TECHNICAL MEMORANDUM NO. 13

ADDENDUM TO FINAL PHASE I  
RFI/RI WORK PLAN

HUMAN HEALTH RISK ASSESSMENT  
MODEL DESCRIPTION FOR OPERABLE UNIT NO. 5

Rocky Flats Plant  
Woman Creek Priority Drainage

FIGURE 3-2

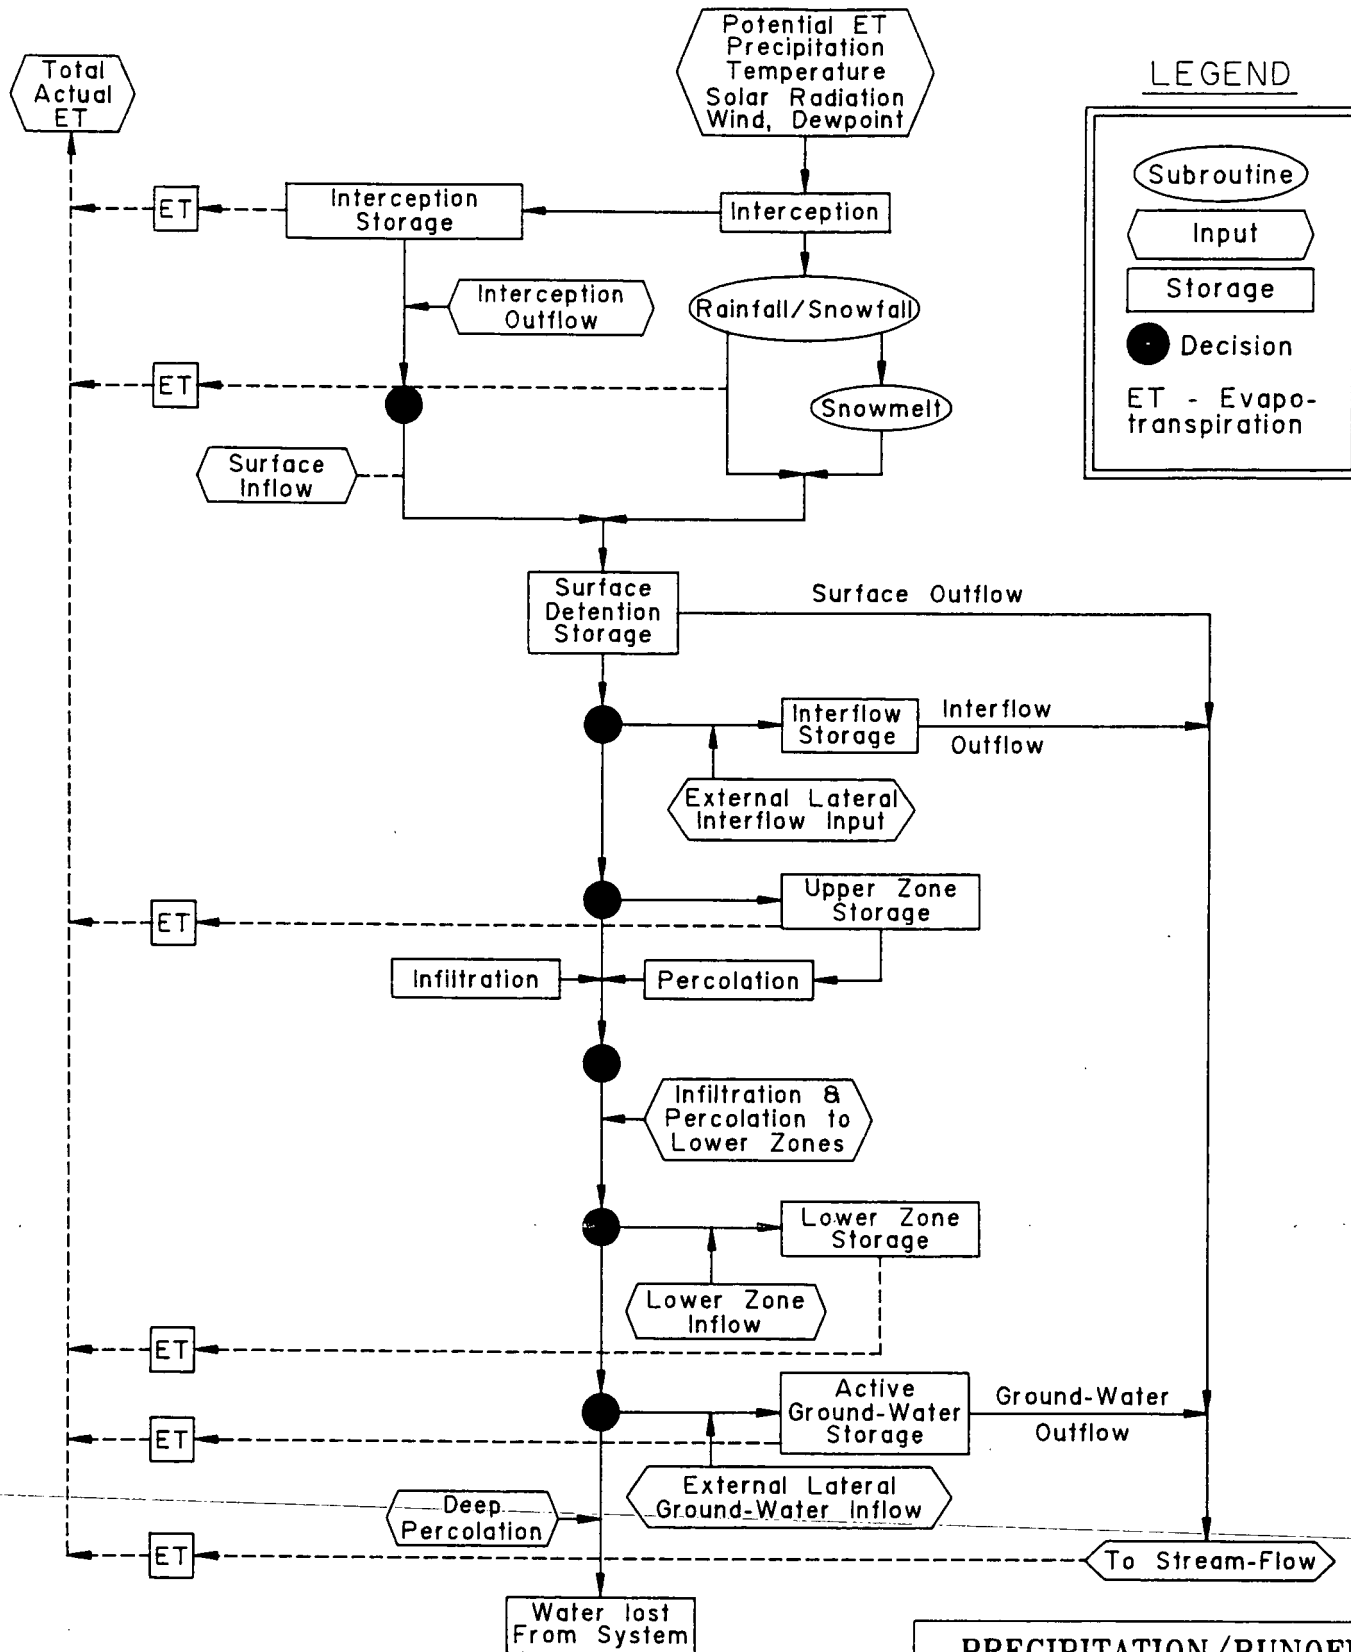
Page	Section or Paragraph	Reviewer's Comment(s)	Originator's Disposition & Comments
	Section 3.4 Surface Water Model	<p>The selected surface water model appears to be complex and data intensive, as indicated by the flow charts on Figures 3-2 and 3-3 and the number of parameters listed in Table 3-2. The possibility of a nonunique model solution is enhanced when there is little or no prior information on parameter values (Anderson and Woessner 1992). Therefore, the successful application of this model will probably require that site-specific data be gathered to derive initial estimates of the 21 parameters listed in Table 3-2 and defined allowable value ranges that are probably more restrictive than those listed in Table 3-2.</p> <p>The description of the technical approach (to be included in the Phase I RFI/RI) should indicate which of the parameters listed in Table 3-2 will rely on initial estimates and value ranges that were based on field data, estimates from literature, or arbitrary values.</p>	<p>The parameters shown in Table 3-2 are divided into four types: Precipitation/Runoff, Soil Erosion, Hydrodynamics, and Contaminant Fate. As stated on page 52 of TM13, most of these parameters are model-calibration parameters and will be varied within the ranges shown in Table 3-2 to produce the best correlation with observed hydrographs, sediment concentrations, and other water-quality concentrations at selected locations on Woman Creek. All of the parameters in the Precipitation/Runoff and Soil Erosion portions of Table 3-2 are calibration parameters determined by formula from field values. In the Hydrodynamic portion of Table 3-2, median bed-sediment diameter will be determined from several site-specific samples. Channel characteristics of Woman Creek will be determined from site-specific data. In the Contaminant Fate portion of Table 3-2, all variables will be initially estimated from literature values but final values will be from the calibration runs. Because this model has been used world-wide in many different hydrologic settings, numerous experience data are available for all the parameters in Table 3-2.</p>

FIGURE 2-2

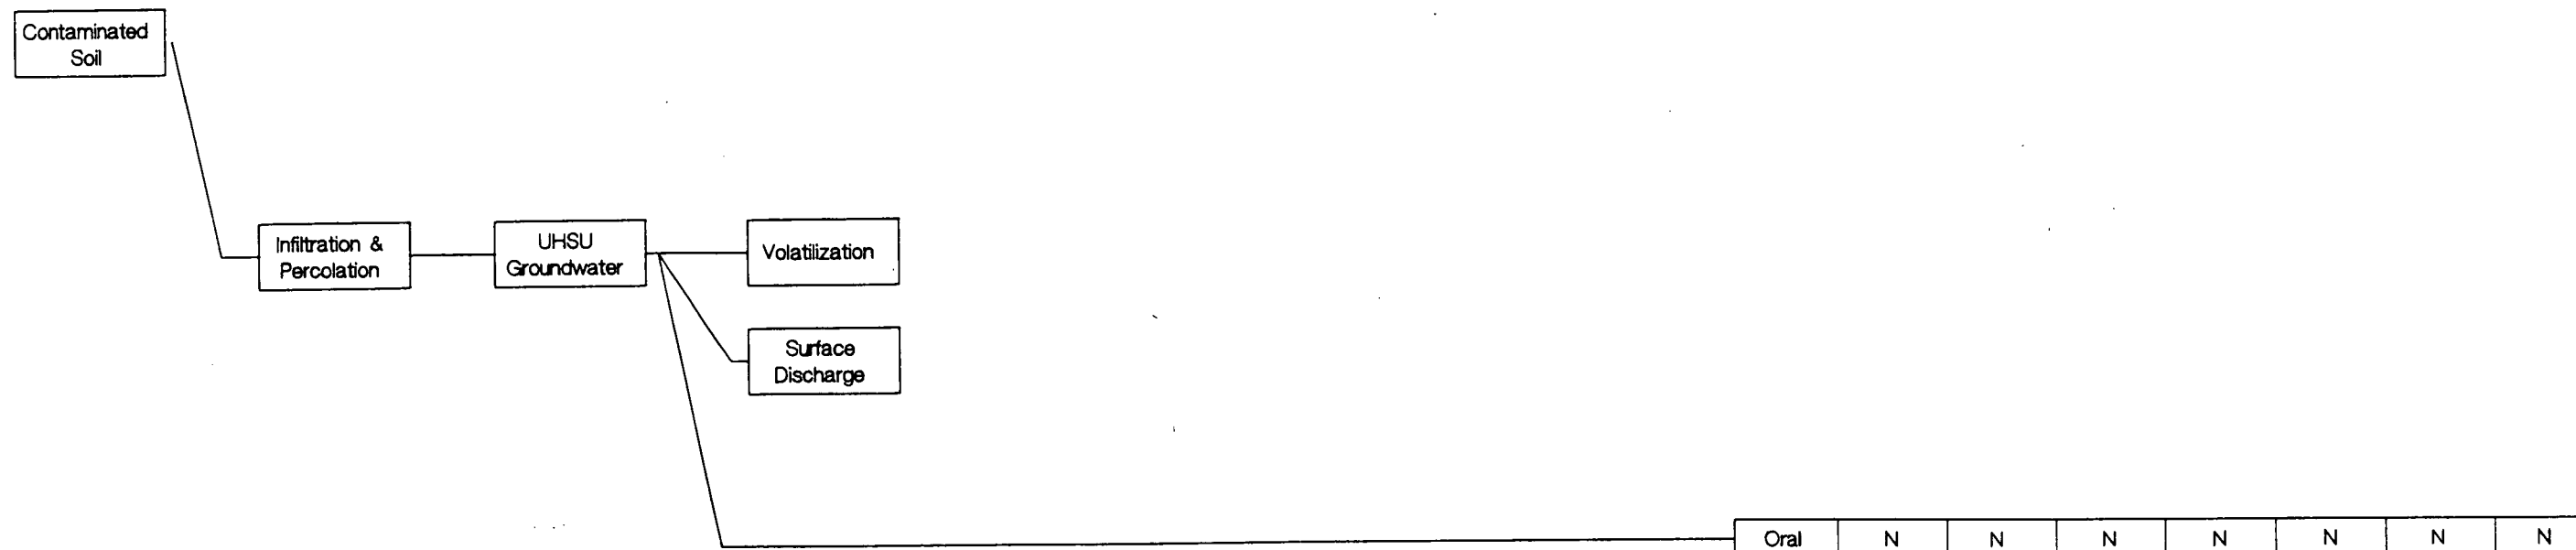
Page	Section or Paragraph	Reviewer's Comment(s)	Originator's Disposition & Comments
	Section 2, Figures 2-2, 2-4, and 2-6 (continued)	<p>approach is used, it could compromise the risk assessment and result in a significant underestimation of risk.</p> <p>An acceptable approach is to determine whether an exposure pathway is complete or incomplete. Incomplete pathways can be ignored, but risk for all complete pathways should be quantified. EPA's comments on Technical Memorandum 12, Exposure Scenarios for Operable Unit 5, address the exposure pathways which must be quantitatively evaluated in the risk assessment. TM13 needs to be consistent with TM12 and recognize the following exposure pathways as complete:</p> <ul style="list-style-type: none"><li>a. Groundwater ingestion by future on site residents</li><li>b. Inhalation of vapors inside future on site residences</li><li>c. Inhalation of vapors while showering by future on site residents</li><li>d. Dermal contact with groundwater by future on site residents</li><li>e. Particulate inhalation by future on site residents</li></ul>

Page	Section or Paragraph	Reviewer's Comment(s)	Originator's Disposition & Comments
	Figures 2-2 and 2-4 (continued)	levels of the year are measured. A well screened in this alluvium will exceed the daily water requirement of 240 gallons that is used in EG&G's domestic water supply analyses as a minimum requirement for a domestic use well. Therefore, ingestion of groundwater would be considered a potential exposure pathway in the Woman Creek valley fill alluvium on the basis of EG&G's own criterion for domestic well production.	
	Figure 2-3	The hydrogeologic profile shown in Figure 2-3 does not depict potential groundwater pathways through bedrock. A bedrock groundwater pathway should be depicted on Figure 2-3.	Figure 2-3 does not depict potential bedrock groundwater pathways for two reasons. First, suspected contamination exists in the Upper Hydrostratigraphic Unit (UHSU), which includes subcropping bedrock sandstones. Additionally, geologic characteristics of the OU indicate that a pathway from the UHSU into the underlying bedrock is not likely, since the OU is underlain by the claystones and silty claystones of the Arapahoe and Laramie Formations. The purpose of this model is to support the Risk Assessment, and the risk for contaminants to impact the public health appears to be greatest in the UHSU.

9208151111	FIGURE 2-4
	AUG. 1994

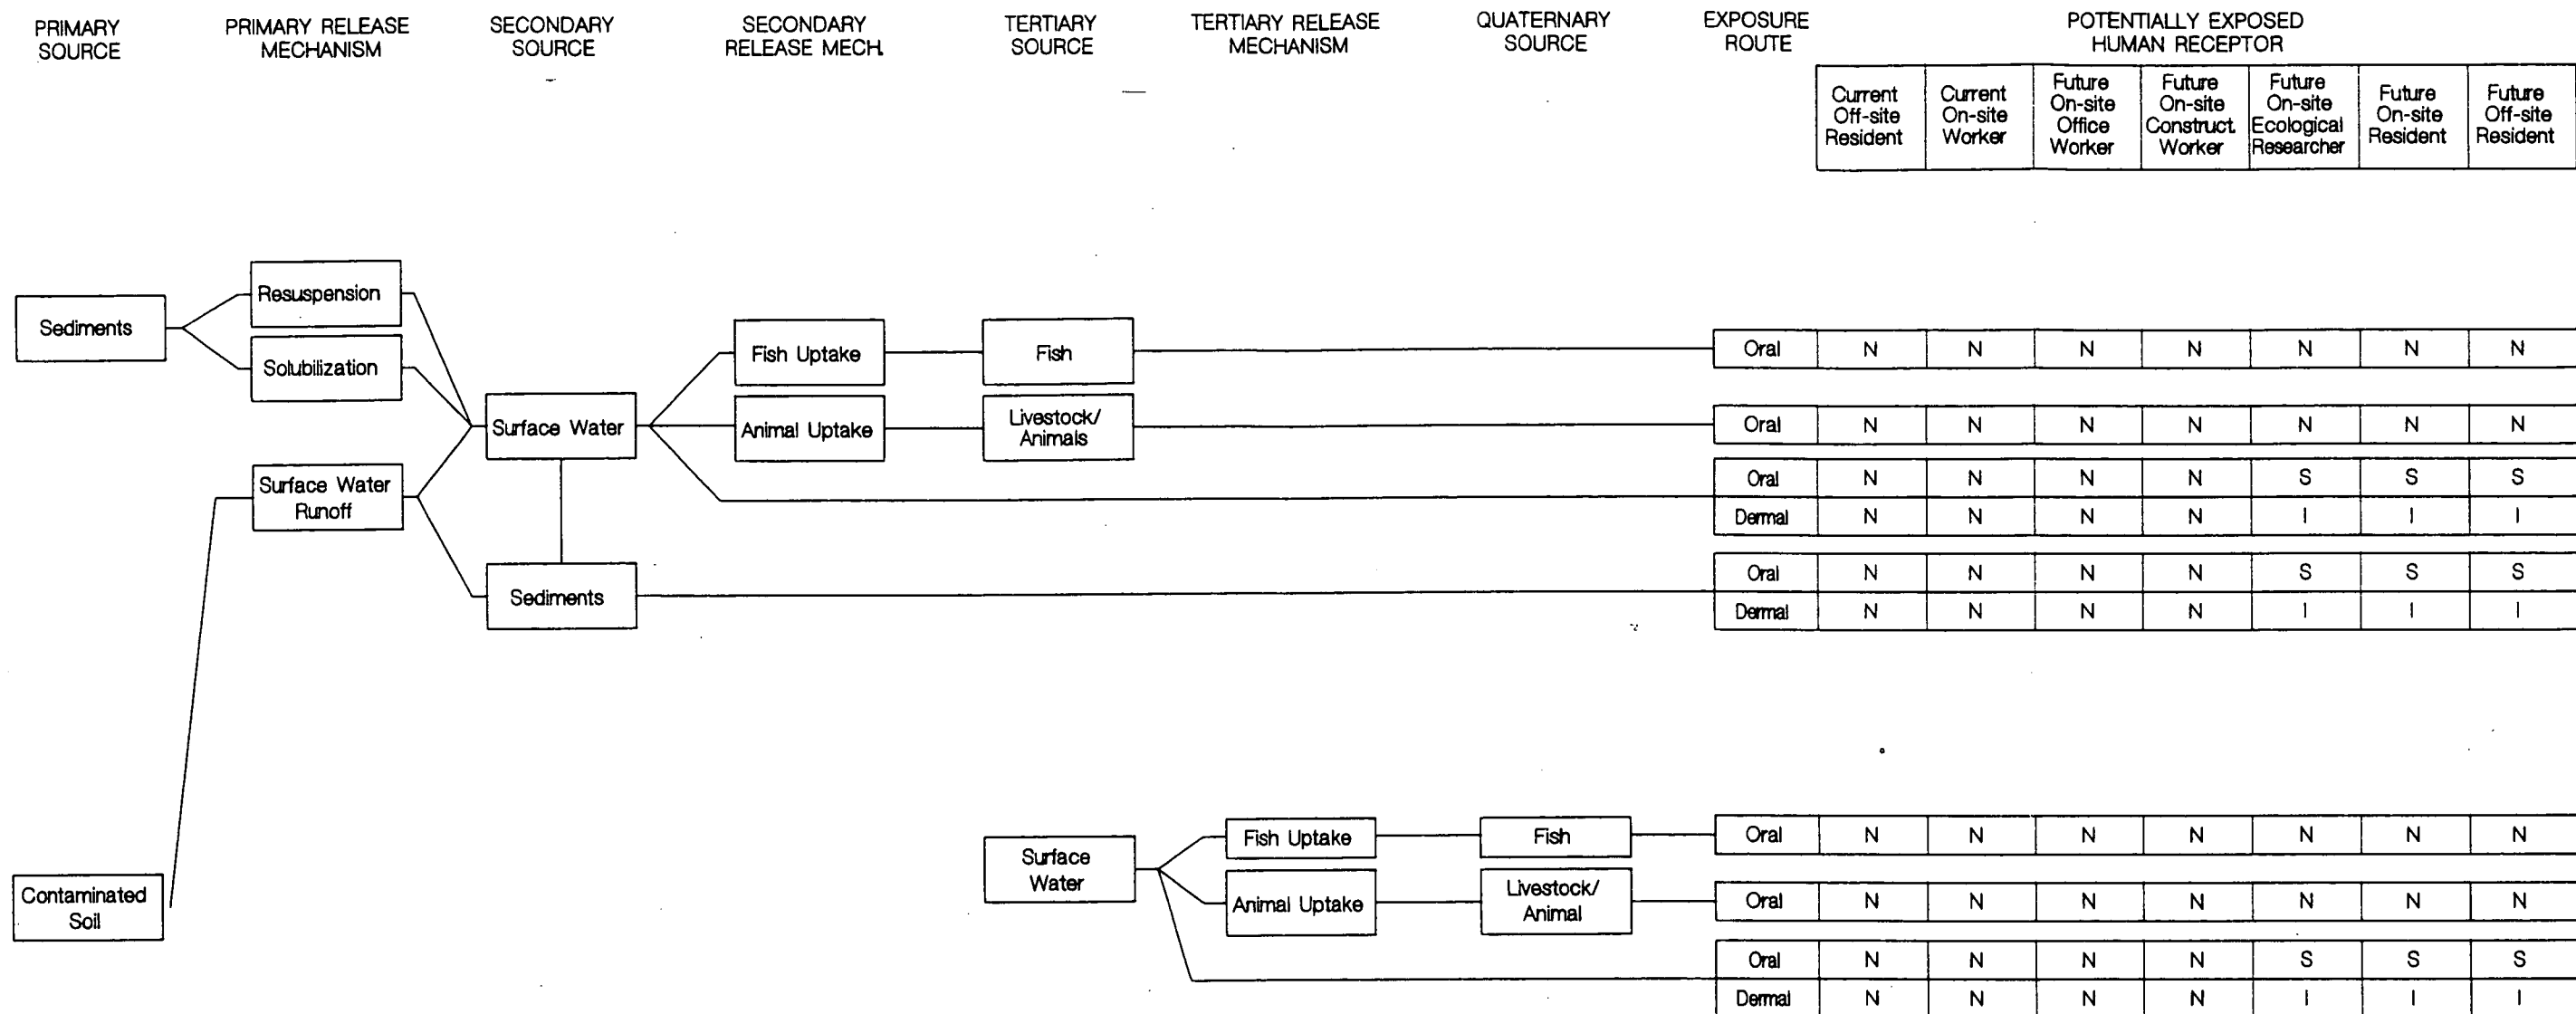
Page	Section or Paragraph	Reviewer's Comment(s)	Originator's Disposition & Comments
	Figure 2-4	Figure 2-4 seems to exclude domestic use of ground water, is this agreed upon? There is no minimum defined by the State Engineers Office or by WQCD that precludes domestic use of any ground water that can be brought to the surface. Therefore, we think domestic use of ground water should be part of the risk assessment if a residential scenario is used.	The CSM was initially presented in the OU5 EATM, TM12, and comments were received from the agencies. Responses to these additional comments on the CSM cannot be drafted until the responses pending on TM12 are resolved.
33	Section 3.2.1	BCF3 may not work as well as advertised, especially for a steady state model with a single layer. It may be a good idea to have an alternate model for variably saturated conditions.	At this time, we believe BCF2 will work for a steady state model. If difficulties arise, a second layer can be added and/or a transient model with small time steps, for a very long time period, can be used as an alternate. If extreme difficulties arise, we have experience using SWIFT III for water table conditions.
